DRAWN: CHEN	DATED: SOCT02	COMPANY: ARTCOM LIMITED		
		TITLE: ARTCOM RF MODULE(BASE)		
CHECKED:	DATED:	PCB FILE: 2G4WBMX3.job		
		L O O J O O		
QUALITY CONTROL:	DATED:	SCALE:	SIZE: A3	REV: 0
		CODE:	DRAWING NO:	SHEET: 1 OF 1
RELEASED:	DATED:

COMPANY: ARTCOM LIMITED			
TITLE: C600 HANDSET			
FLAG:			
L	1	0	PCB FILE: C600xxxxxxxx
J	B	0	
SCALE:		SIZE: A3	REV: 0
DRAWING NO:		SHEET: 1 OF 4

DRAWN: CHEN	DATED: SOCT02	COMPANY: ARTCOM LIMITED		
		TITLE: ARTCOM RF MODULE(HANDSET)		
CHECKED:	DATED:	PCB FILE: 2G4WHMX2.job		
		L O O J O O		
QUALITY CONTROL:	DATED:	SCALE:	SIZE: A3	REV: 0
		CODE:	DRAWING NO:	SHEET: 1 OF 1
RELEASED:	DATED:

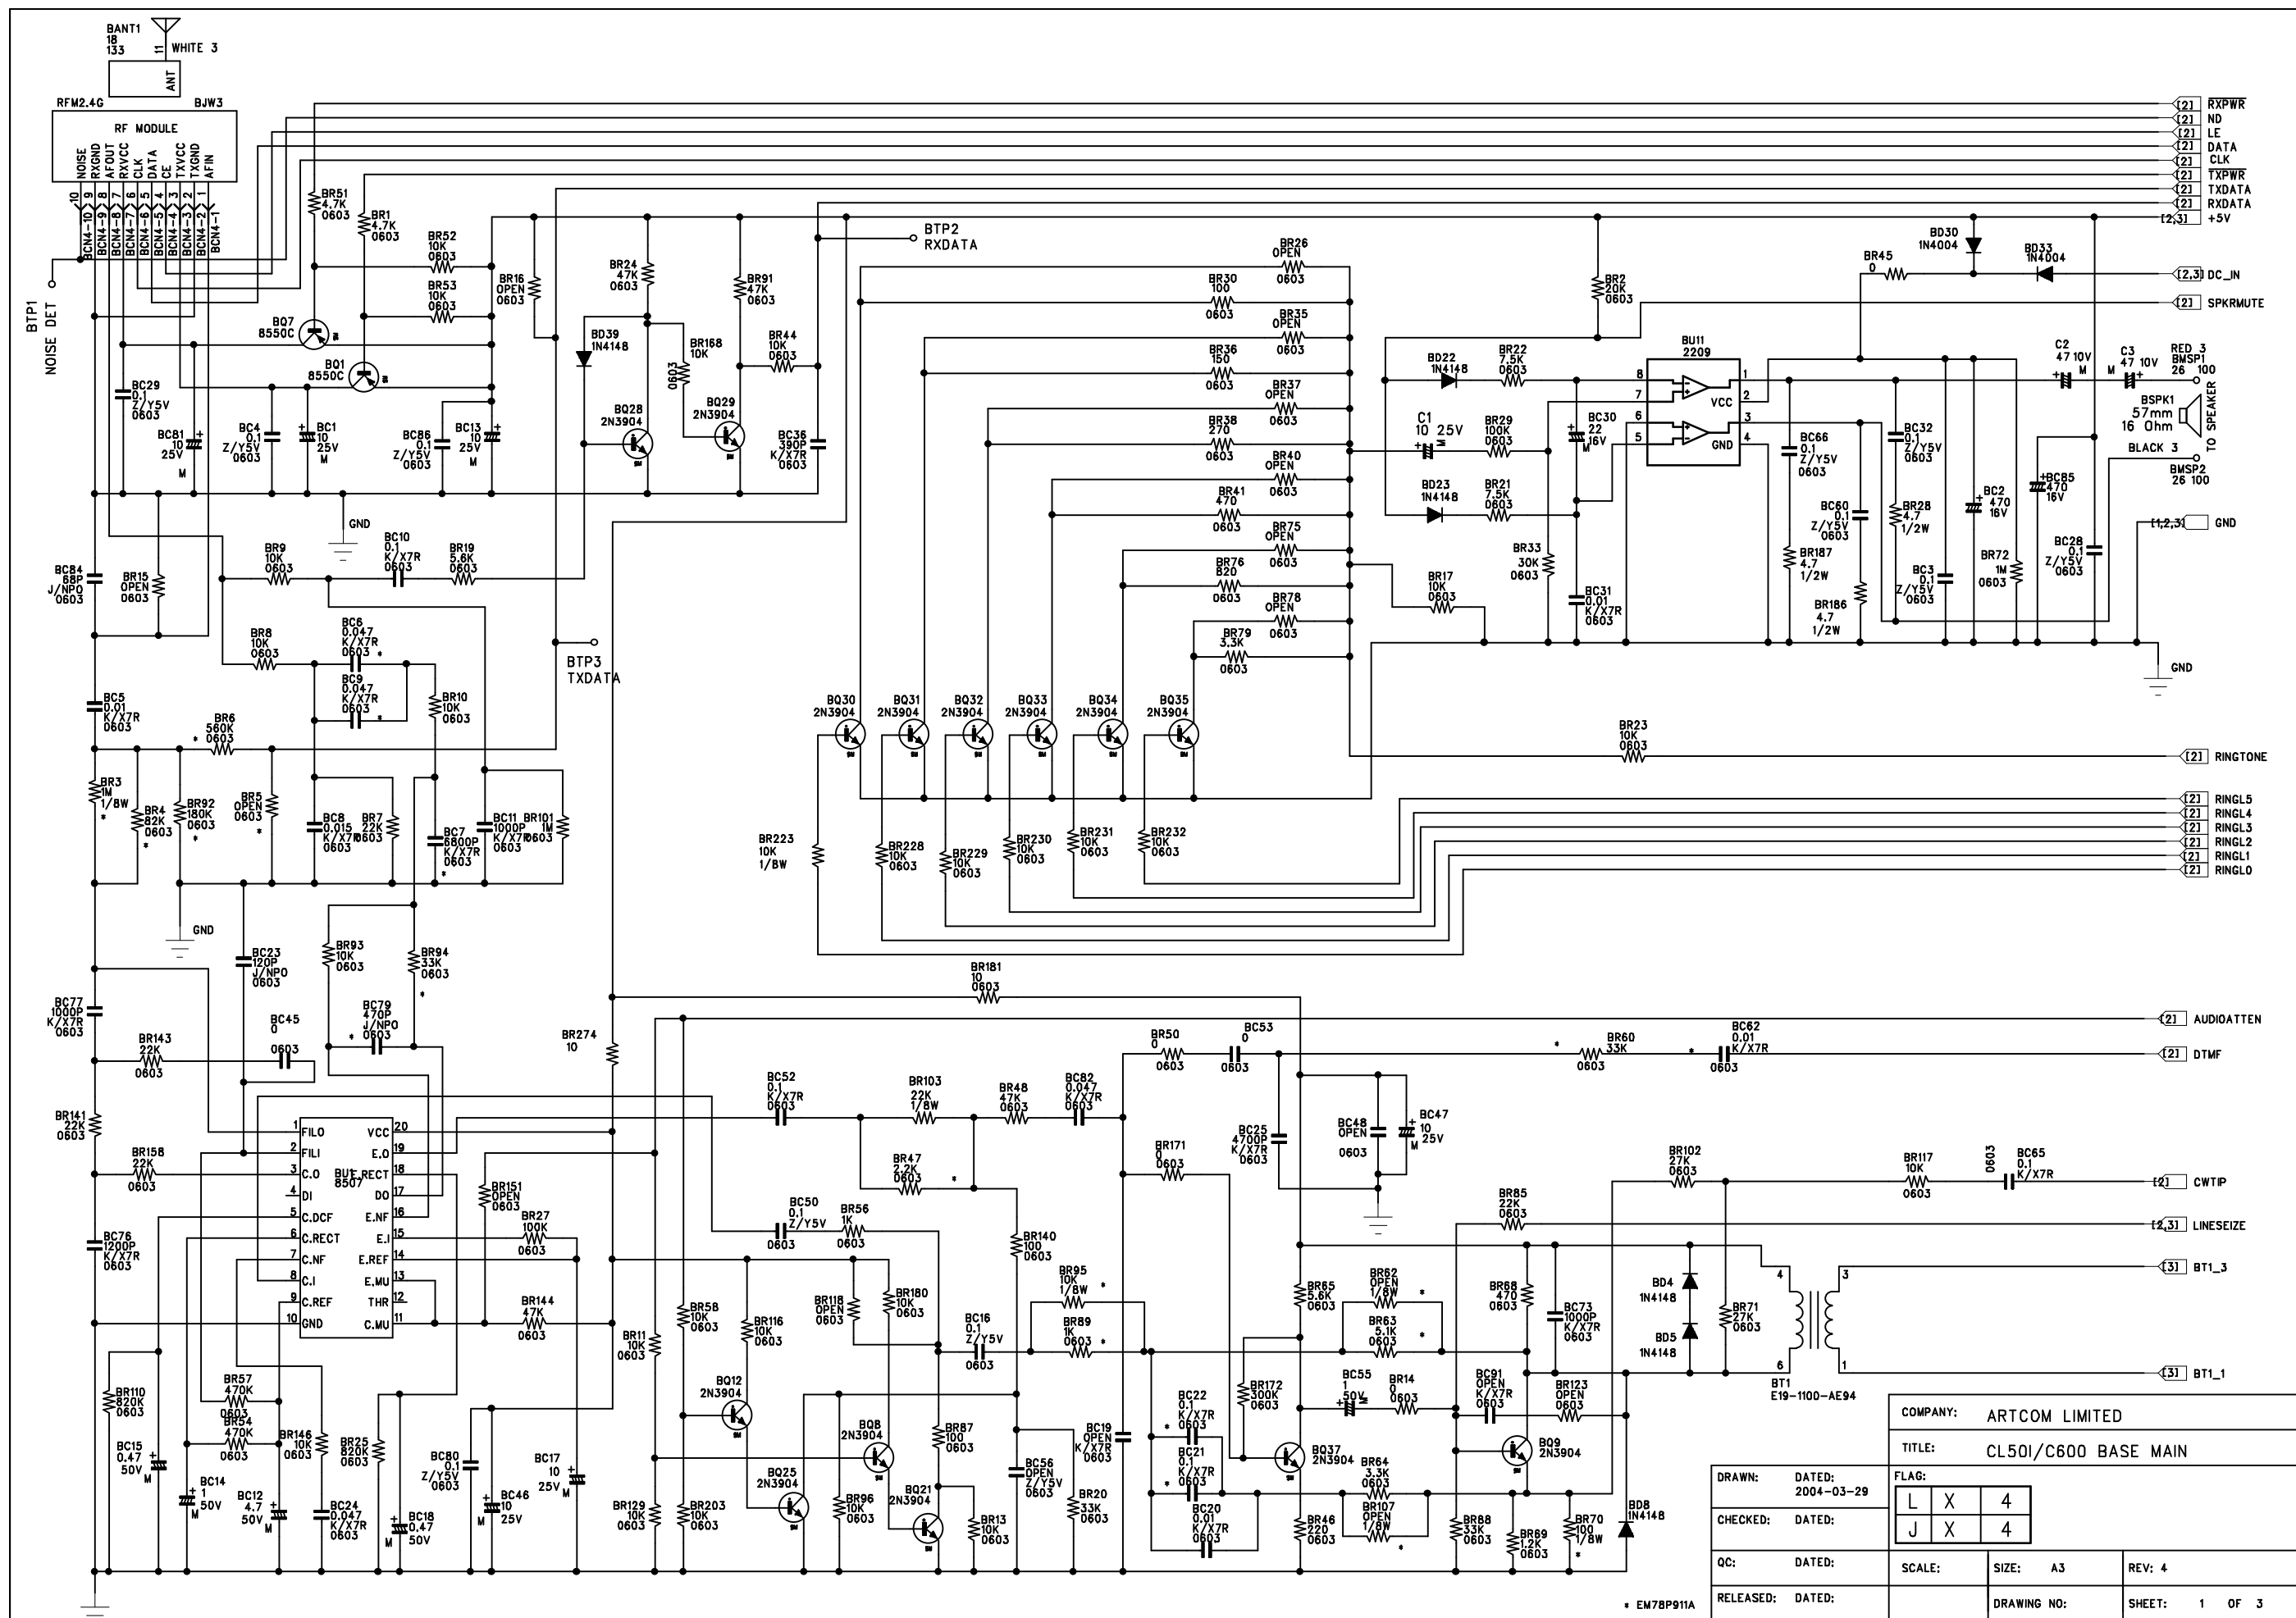
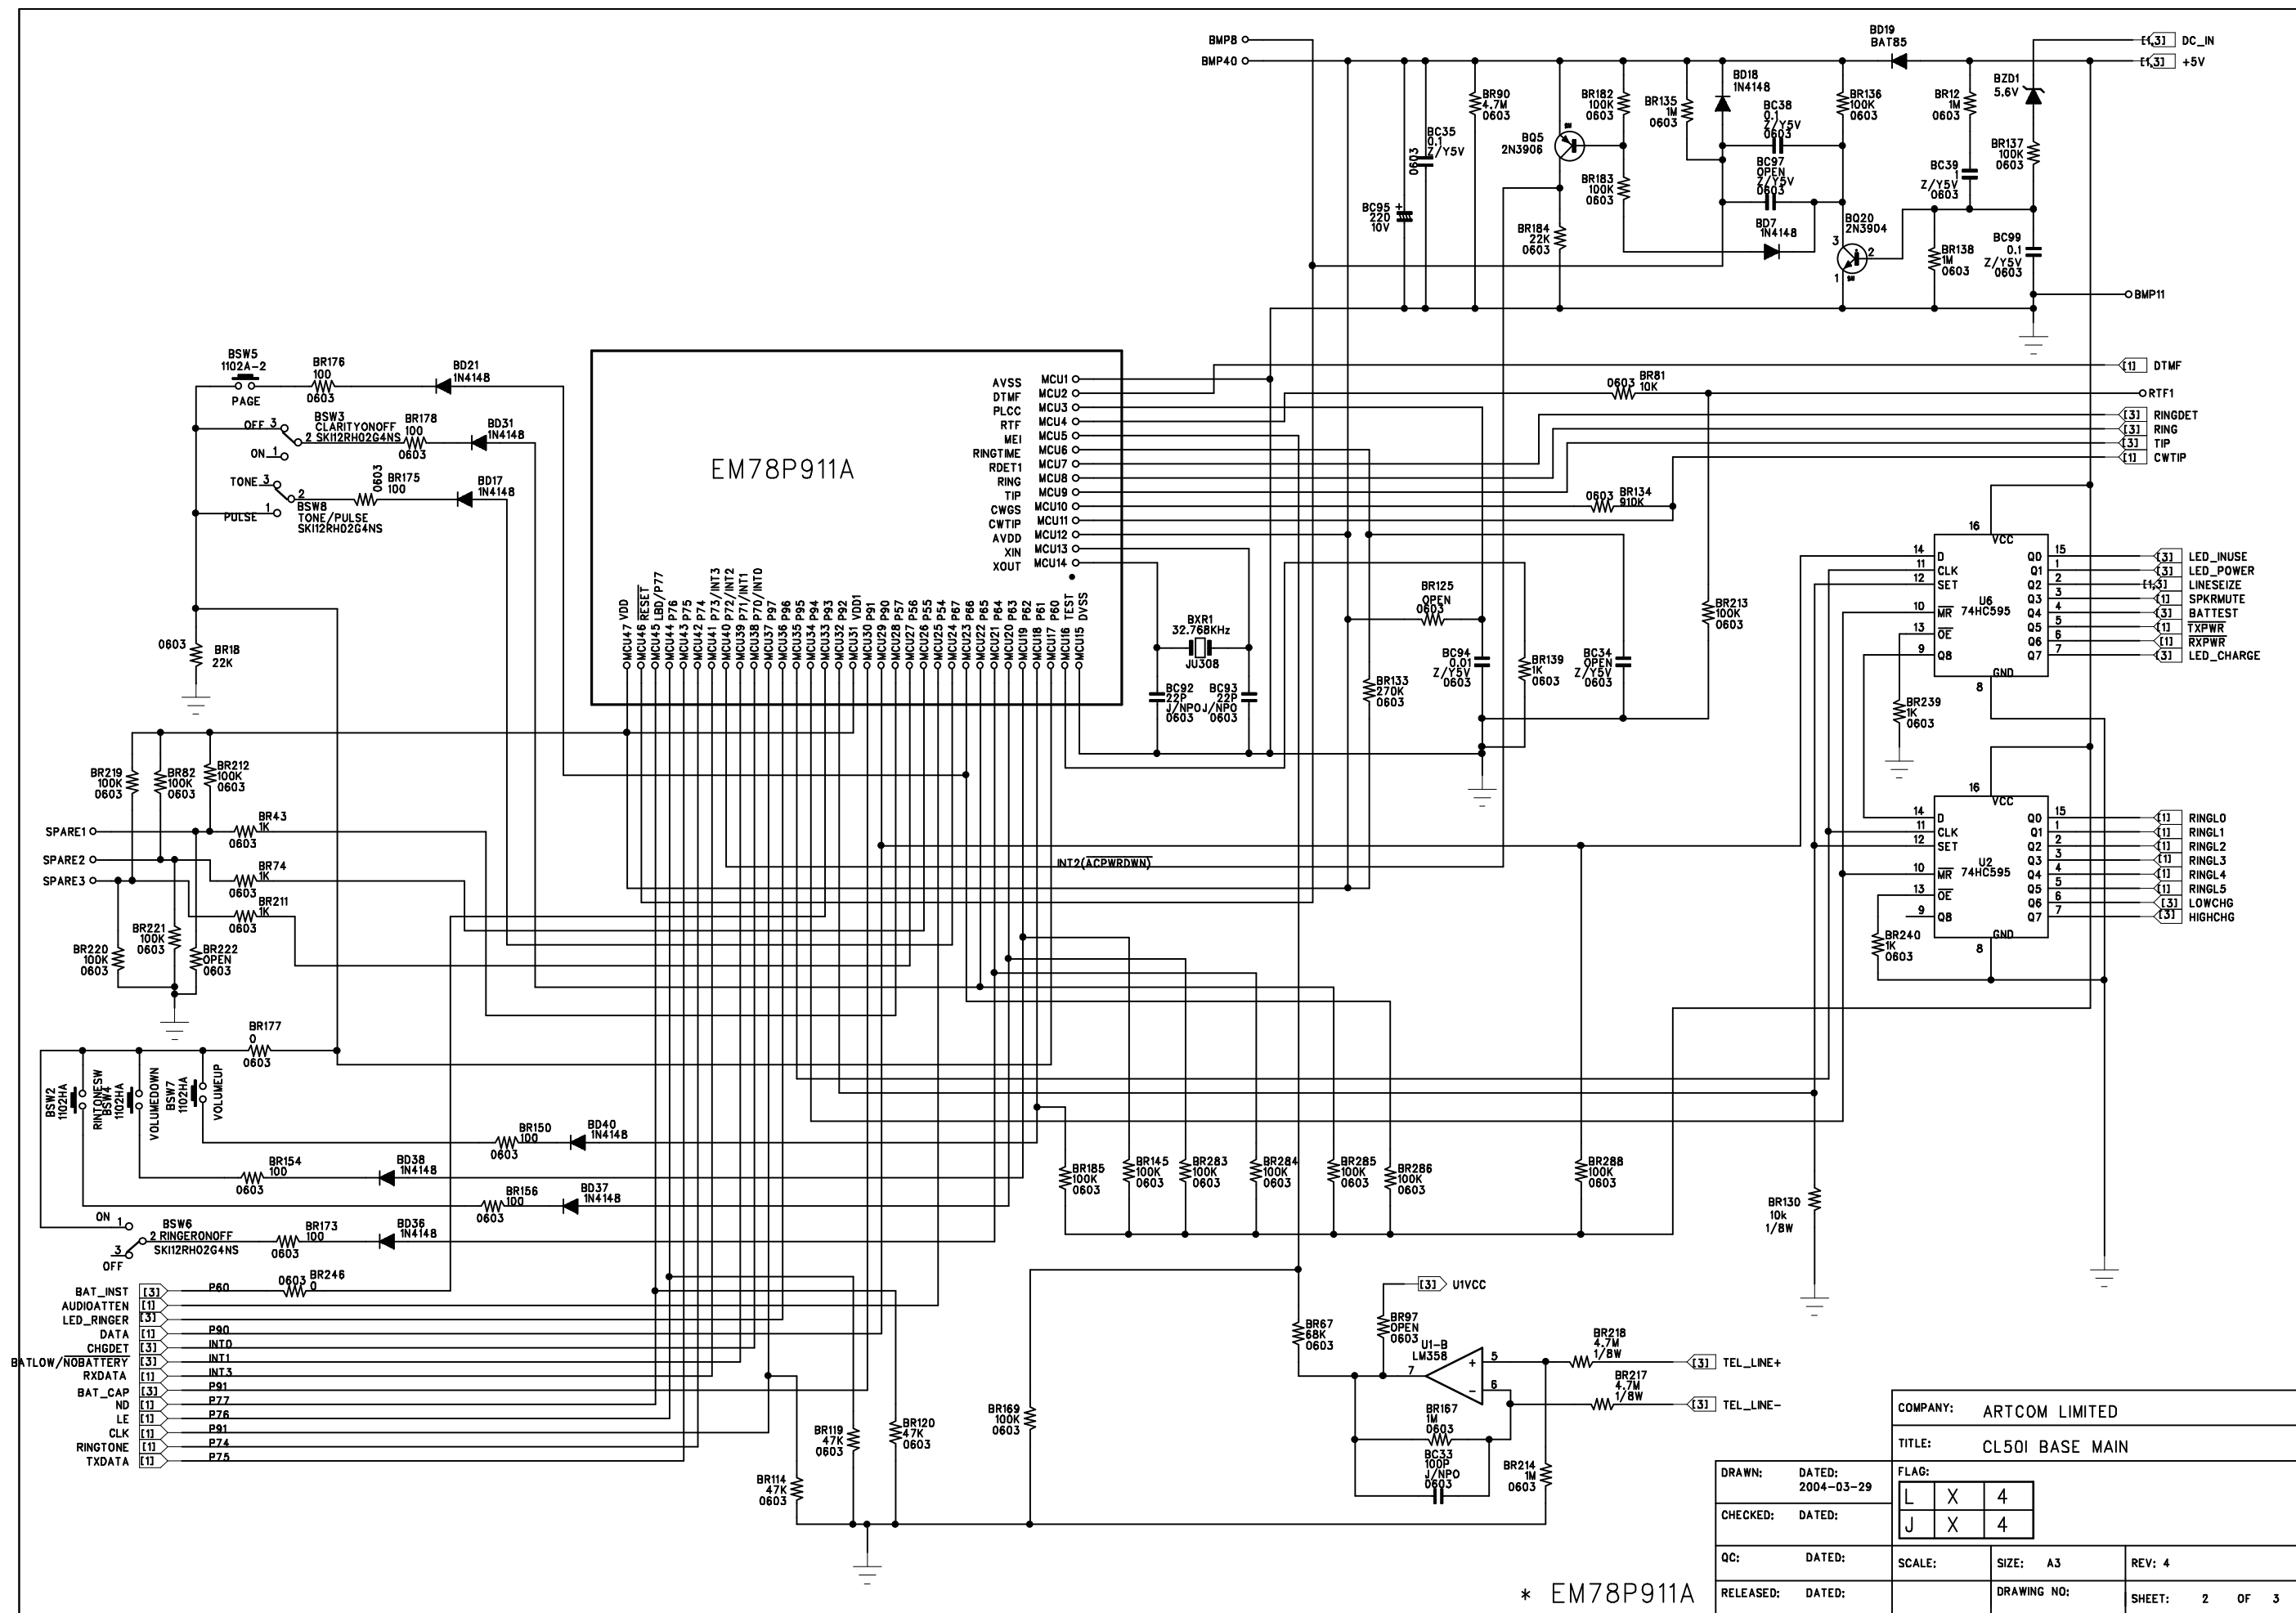
REVISIONS
ECN 02/05/02
1. C12 5P CHANGE TO 6P
2. C17 3P CHANGE TO 4P
3. C44 20P CHANGE TO 24P
ECN 04/13/02
1. VD1 VD2 KDV154C CHANGE TO 1SV214
ECN 04/18/02
1. C51 2.2P CHANGE TO 7P
ECN 04/24/02
1. C12 6P CHNAGE TO 5P
